# UNITED STATES PATENT AND TRADEMARK OFFICE

<b>Office Action Summary</b>	<b>Application No.</b>	<b>Applicant(s)</b>
	10/517,845	JONKKA, ARVO
	Examiner Bena Miller	Art Unit 3725

## DETAILED ACTION

Figure 4 of Durkee

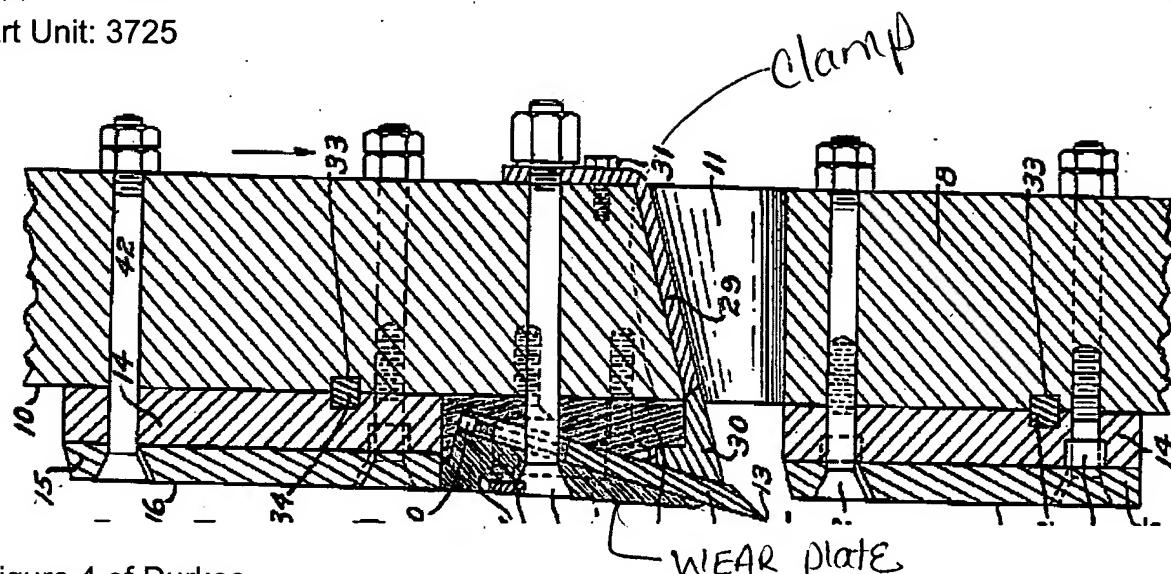
The device of either Durkee or Kershaw meets the limitation of both the method and clamping arrangement of the disclosed invention including the method of forcing (fig.4 or fig. 3, respectively), exerting (fig.4 or fig. 3, respectively) and a knife disc (fig. 3 or fig. 2, respectively); a wear plate (34 or 37, respectively) fastened on the knife side of the disc; a knife (12 or 33, respectively); a clamp (36 or see marked copy fig. 3, respectively; and compressing means exerting a force substantially parallel to an axis of the disc outward from the disc onto the clamp; wherein the knife abuts (note: knife 12 of Durkee abuts via 40) against a bracket of the clamp and the wear plate is provided with a matching groove for the bracket (fig. 4 or fig. 3, respectively), a projection, matching notch and matching groove (fig. 4 of Durkee). Applicants' attention is also directed to the marked copy of figure 4 of Durkee and figure 3 of Kershaw.
